AGREEMENT

WHEREAS, the CRA desires to retain the services of the Contractor to provide the goods and services in accordance with the CRA's Invitation to Bid No. 2022-01-R, and the Contractor's response thereto, all of which are incorporated herein by reference.

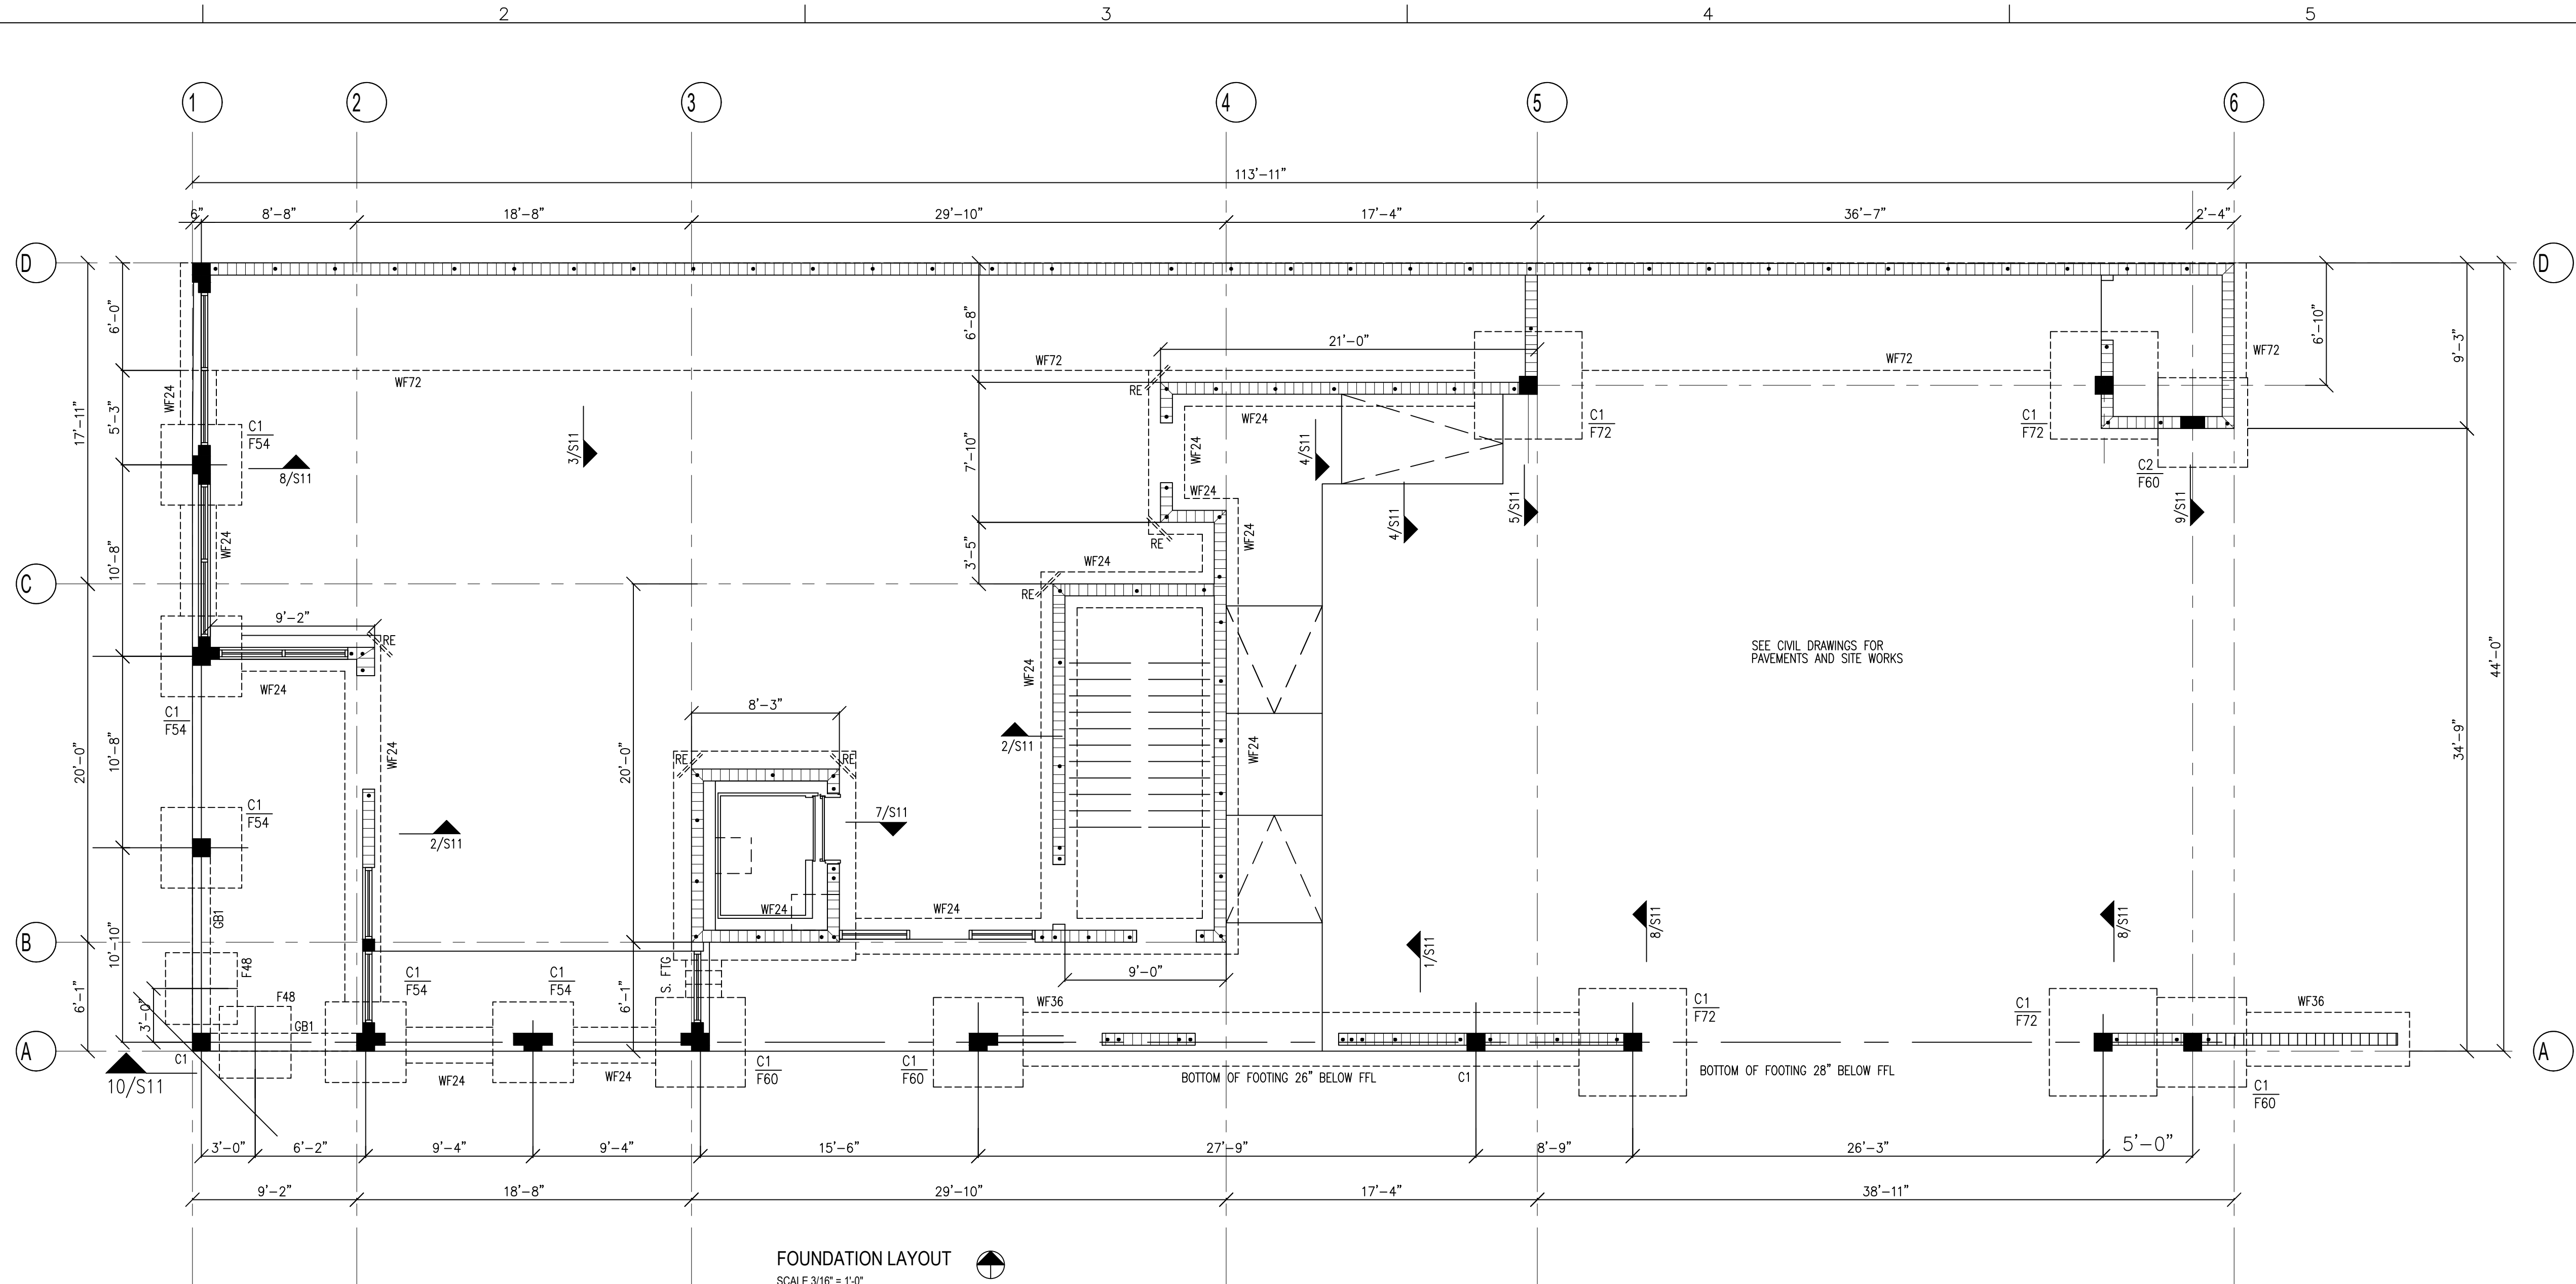
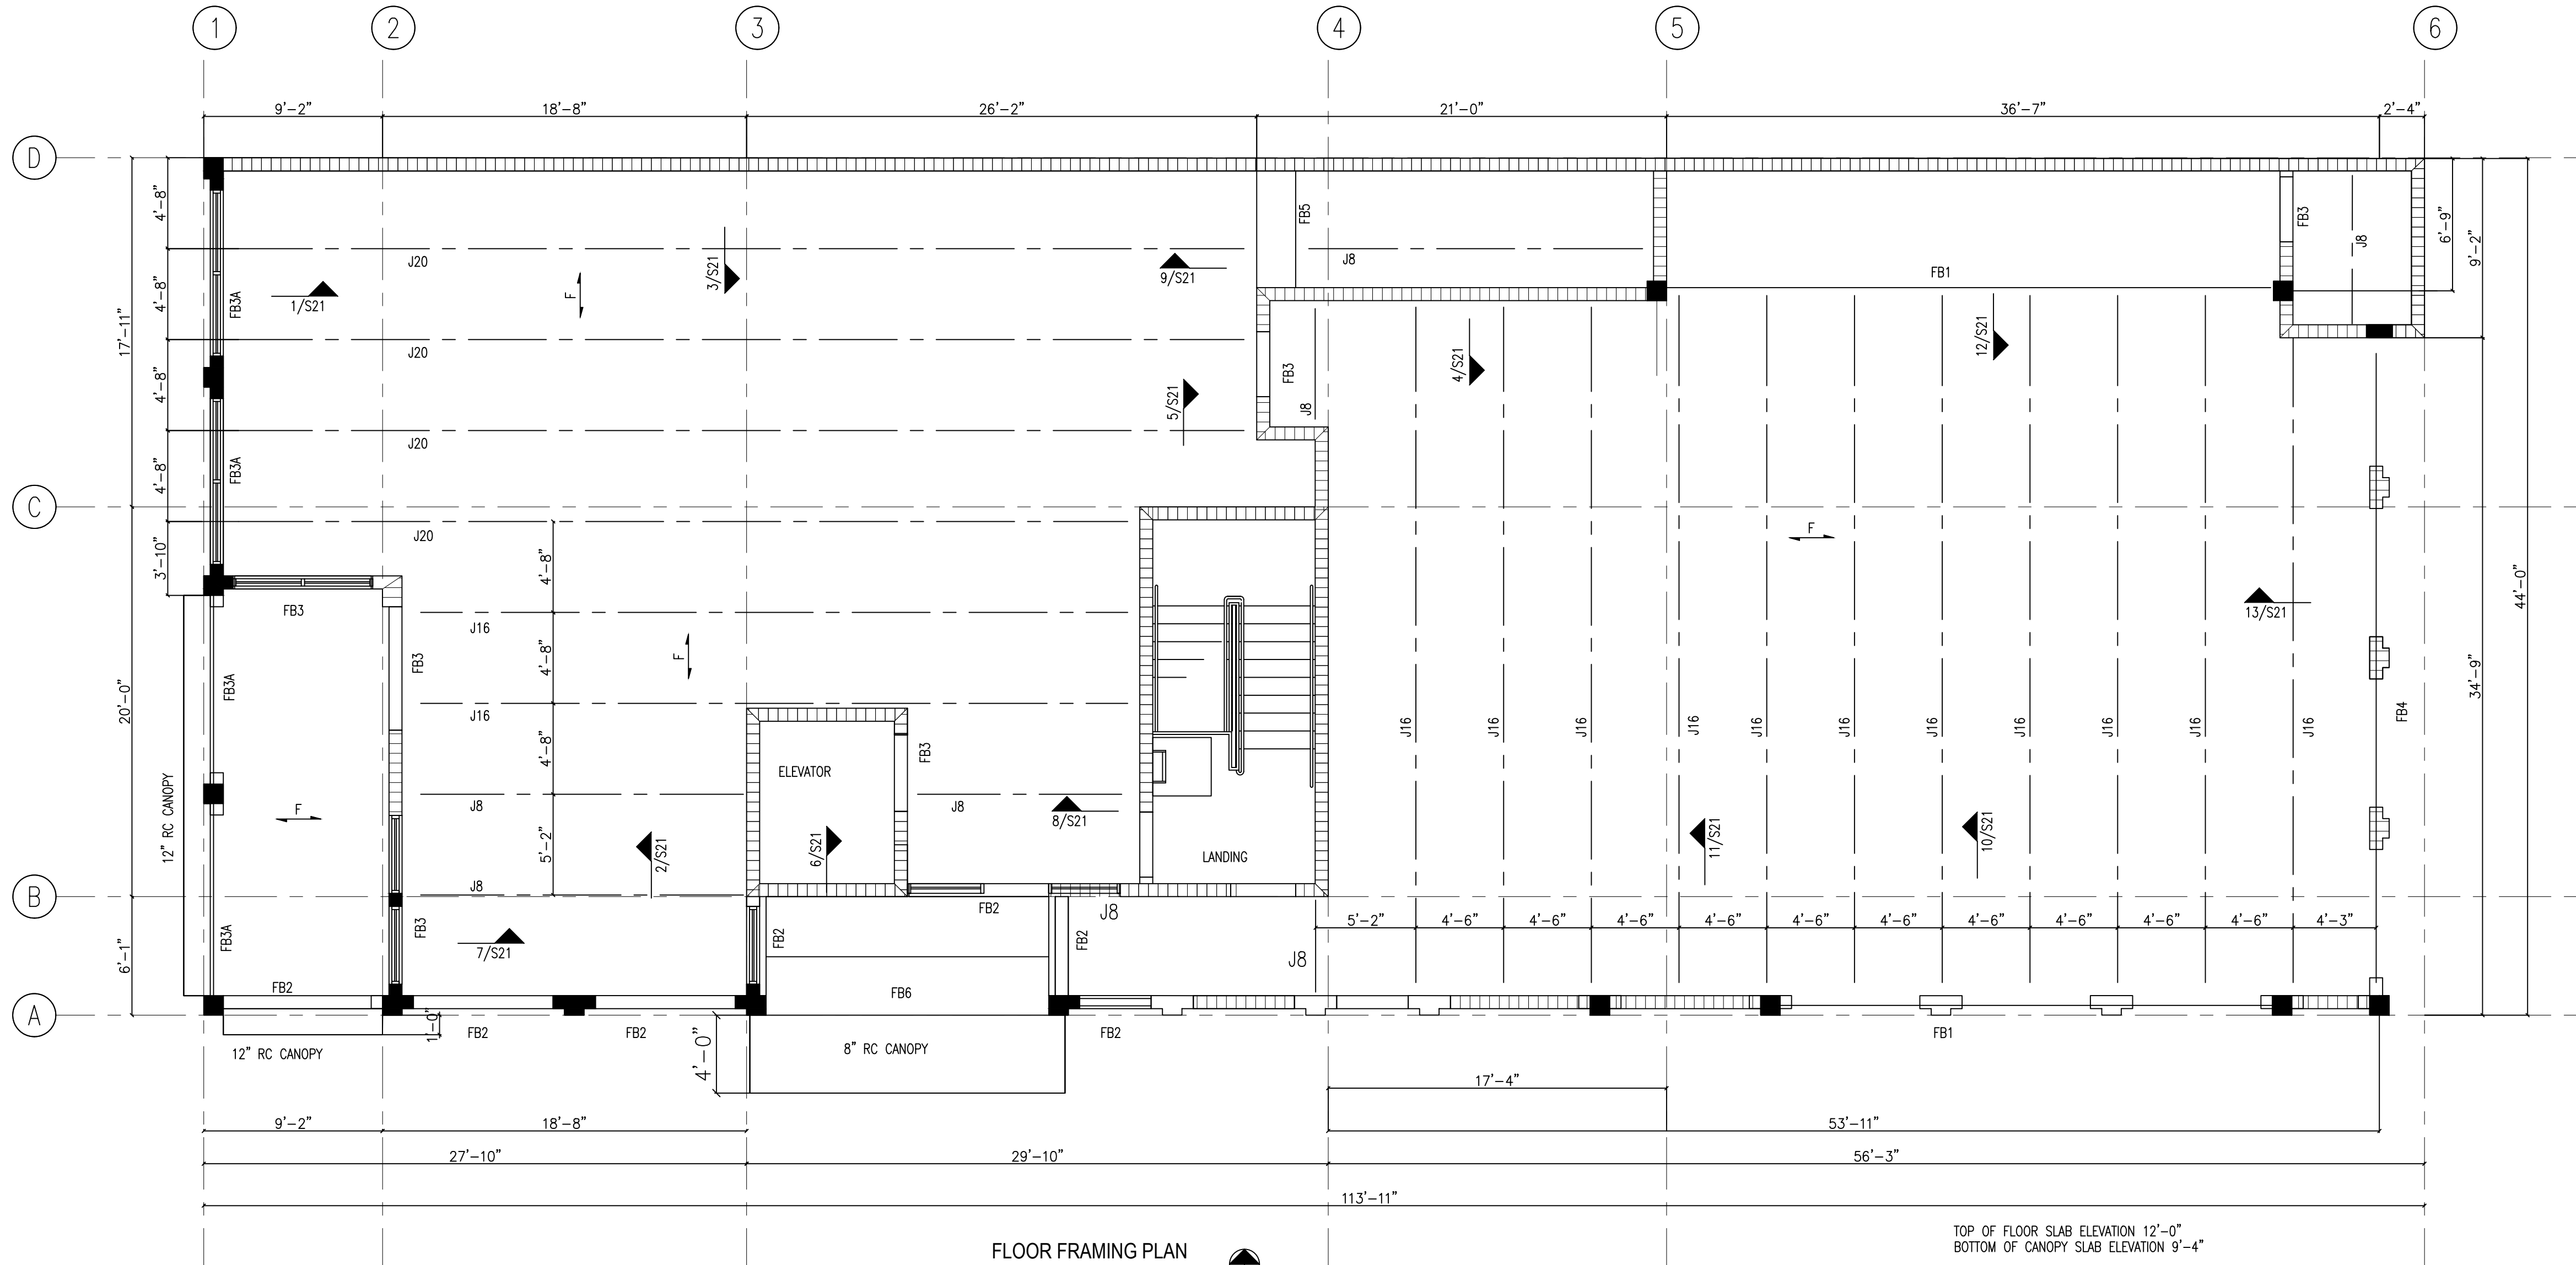
17. **FB1A shows on concrete beam schedule, but it does not show on the floor plan (Drawing S20), please clarify.**

23. **Drawing S20 does not show what kind of beam goes by schedule or will it be considered a couple bond beam. Please clarify.**

FB1A not used in the project. Drawing S20 is attached to this Addendum.

Use double bond beam unless FB shows on wall. Drawing S20 is attached to this Addendum.

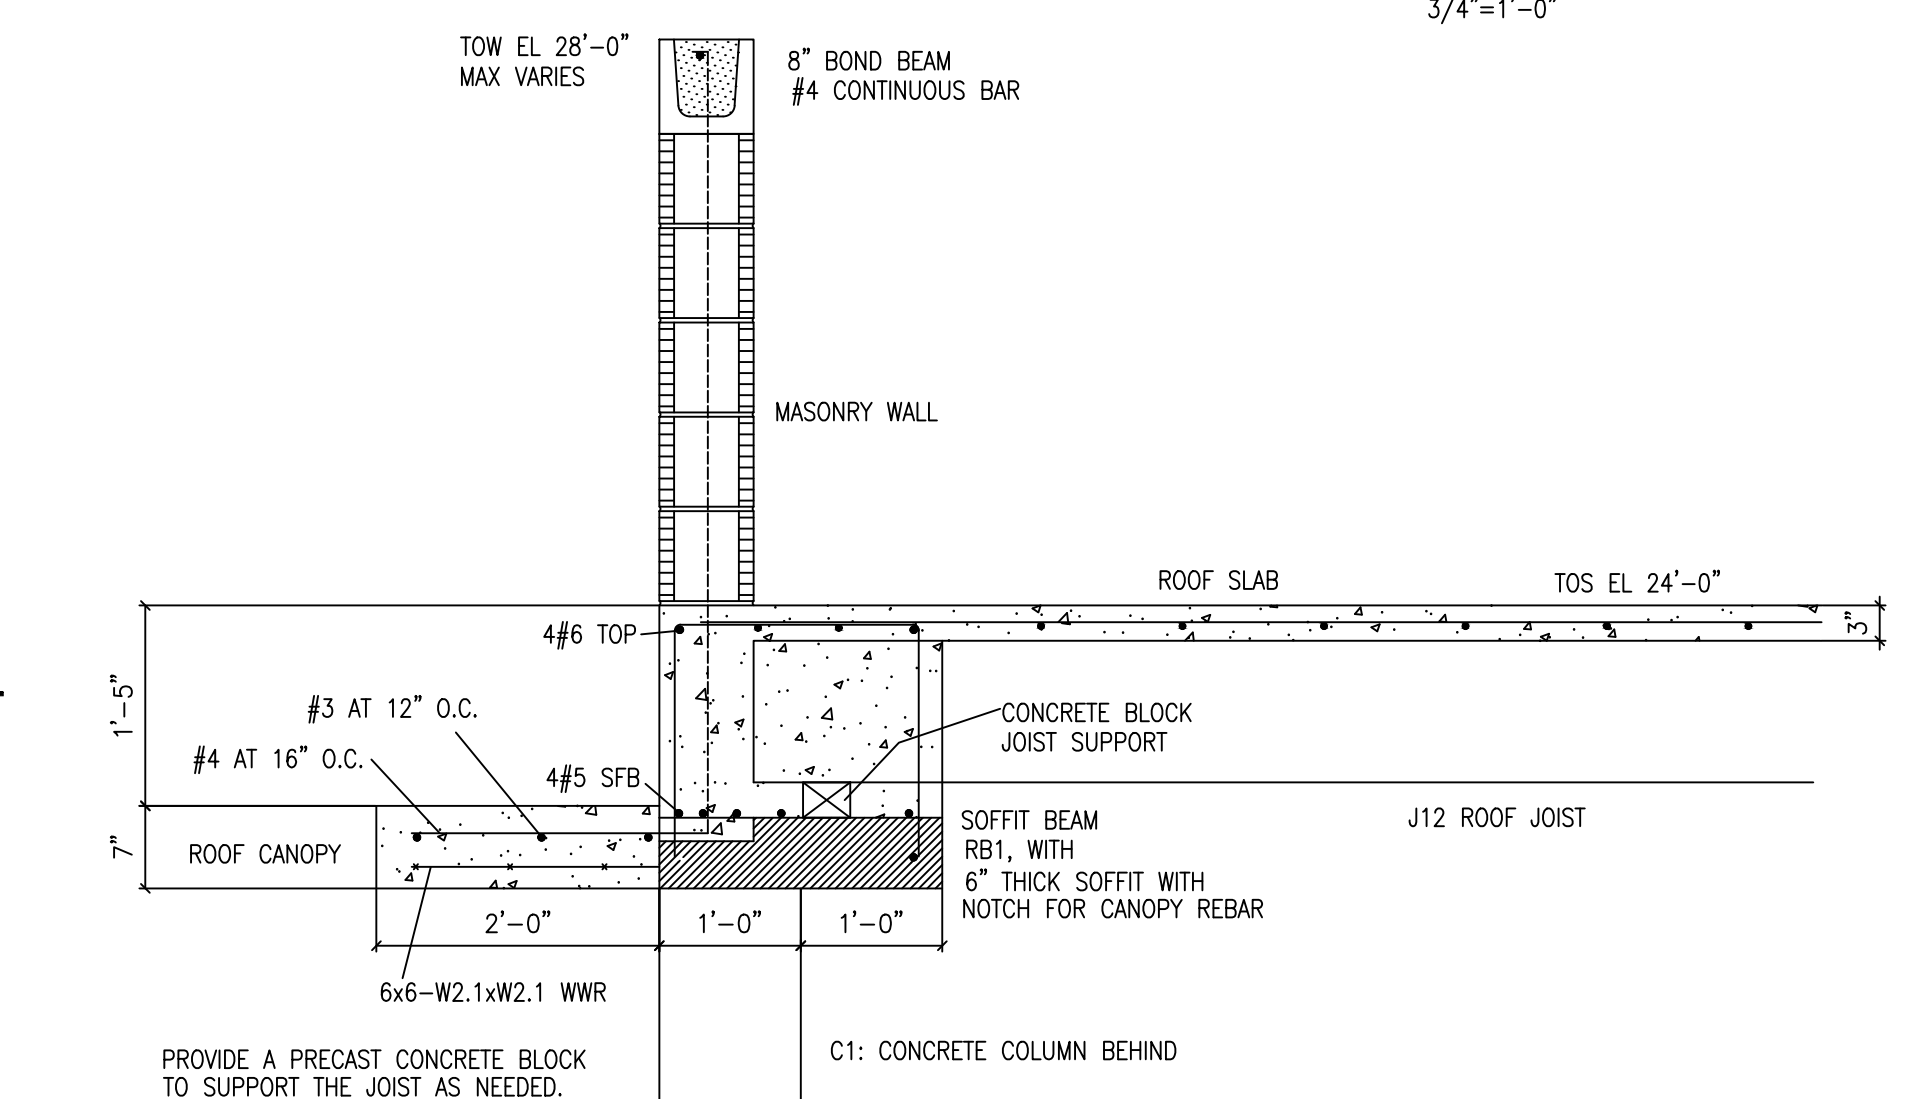
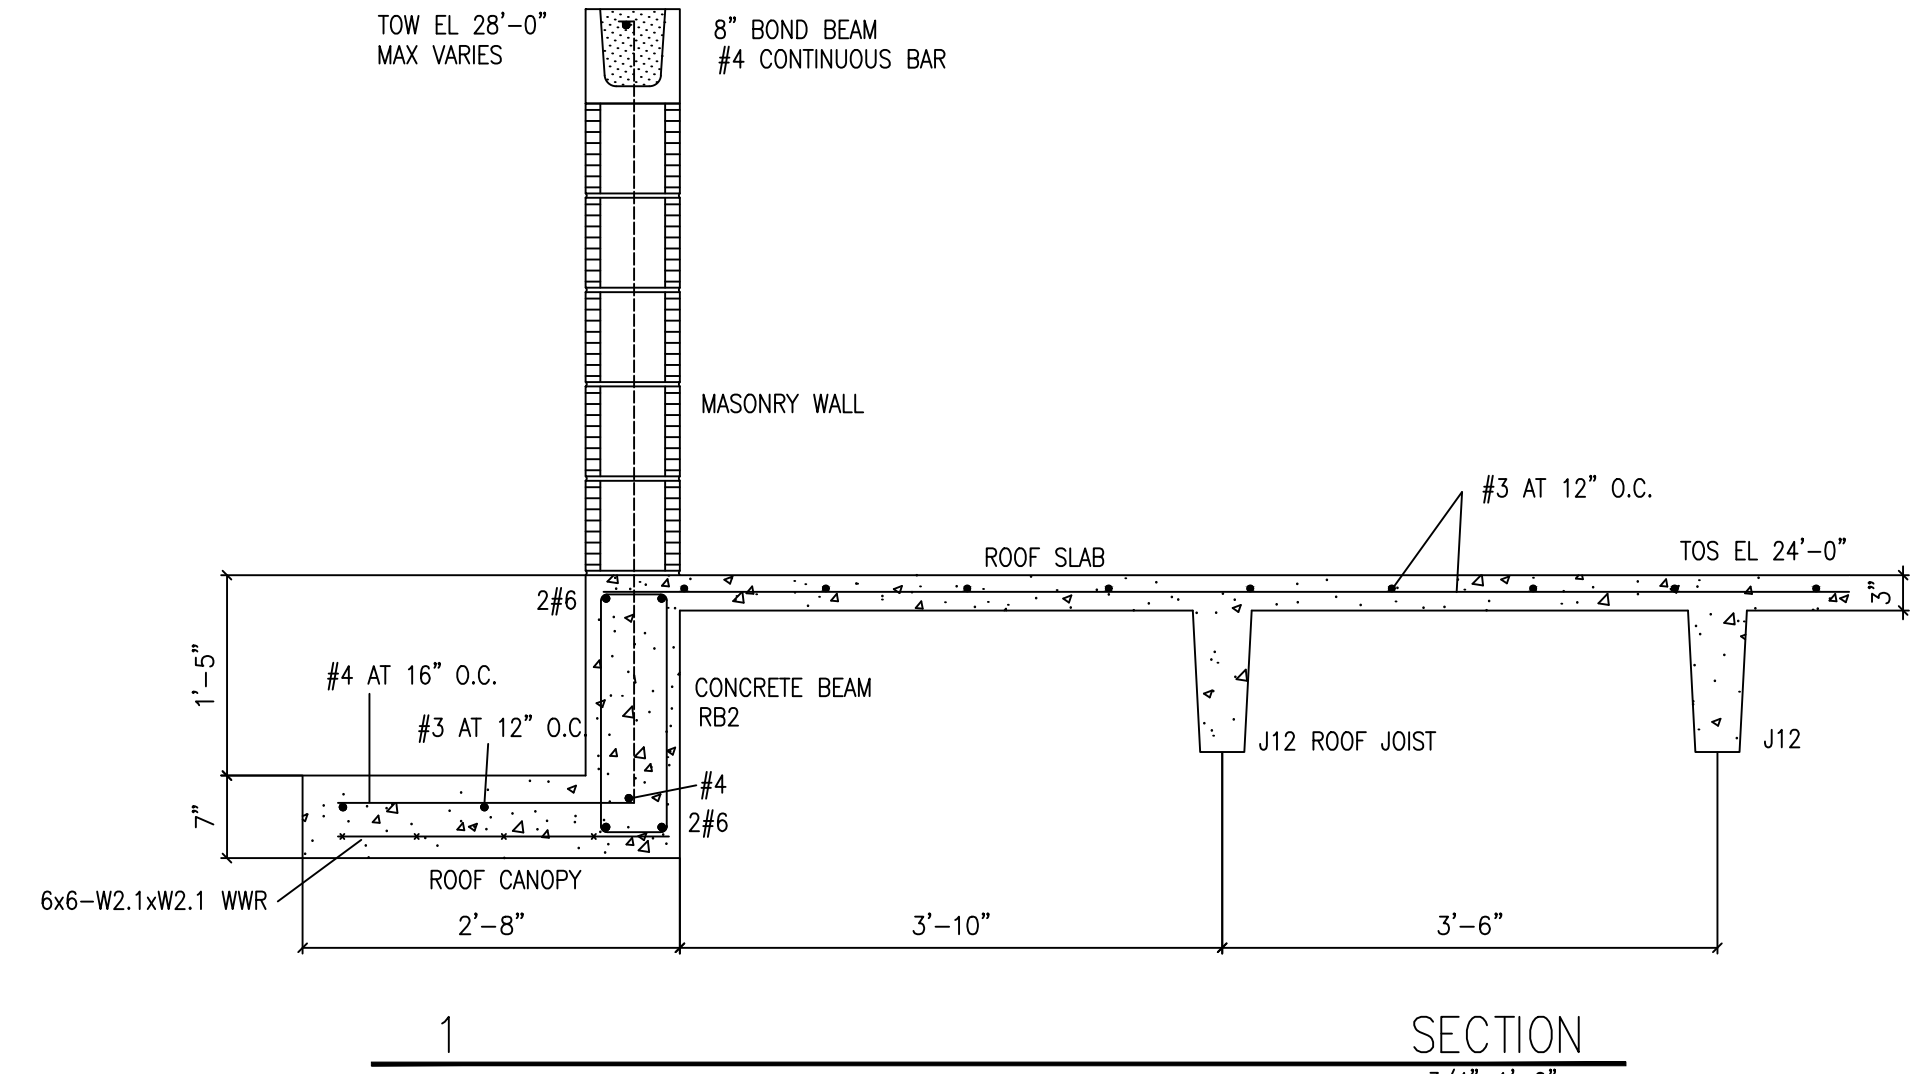
21. **2nd floor and roof framing plans, (Drawings S20 and S30) show a note of the slab with #3 at 12" OC, but on detail 7 (Drawing S22), it shows reinforcement with #4. Please clarify.**

Detail 7 (Drawing S22) revised. Drawing S22 is attached to this Addendum.
